DART AEROSPACE LTD	Work Order:	77336
Description: Crosstube Assembly (205/212/412 High Fwd)	Part Number:	D212-664-141
Inspection Dwg: D212-664-141 Rev: D		Page 1 of 1

DRAWING NO. D212-664-141	TITLE XTUBE ASSY (205/212/412 HI FWD)	REV. D	DART AEROSPACE LTD ENGINEERING ORDER		D.E.O. NO. D212-664-141-D-1	SHEET NO. SHEET 1 OF 2	SCALE NTS
DRAWN	CHECKED	OP	MFG. APPR.	ER	APPROVED	MP	DE APPR.
DATE 11.04.07	DATE 11.04.11		DATE 11.04.12		DATE 11/04/12		DATE 11.04.12

ADD AN INSPECTION WINDOW TO UNDERSIDE OF CROSSTUBE.

REPLACE MAGNOBOND WITH PROSEAL.

**D212-664-141/-141B
ASSEMBLY DETAIL**

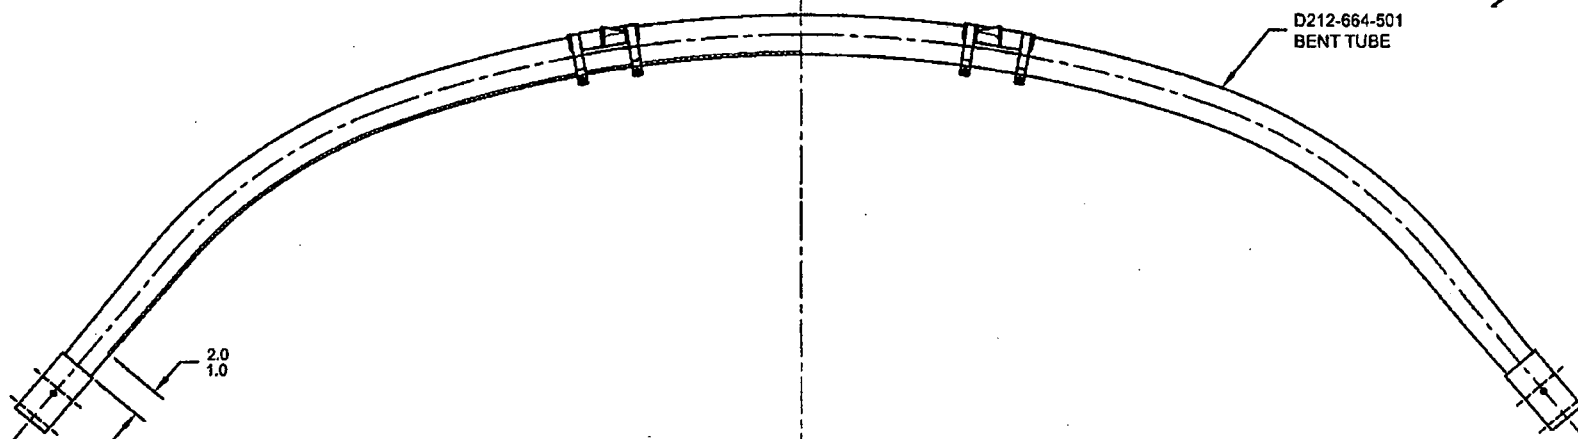
NOTES 2 OF SHEET 1 IS AMENDED AS FOLLOWS:

- 2) FINISH: CHEMICAL CONVERSION COAT PER DART QSI 005 4.1
PRIME INSIDE AND OUTSIDE PER DART QSI 005 4.2
MASK UNDERSIDE OF CROSSTUBE AS SHOWN (HATCHED AREA) AND
PAINT OUTSIDE PER DART QSI 005 4.2
REMOVE MASKING AND APPLY CLEAR COAT

- 2) FINISH: CHEMICAL CONVERSION COAT PER DART QSI 005 4.1
PRIME INSIDE AND OUTSIDE PER DART QSI 005 4.2
PAINT OUTSIDE PER DART QSI 005 4.2

MASK AREA PRIOR TO PAINTING.
REMOVE MASKING AFTER PAINT
AND APPLY CLEAR COAT
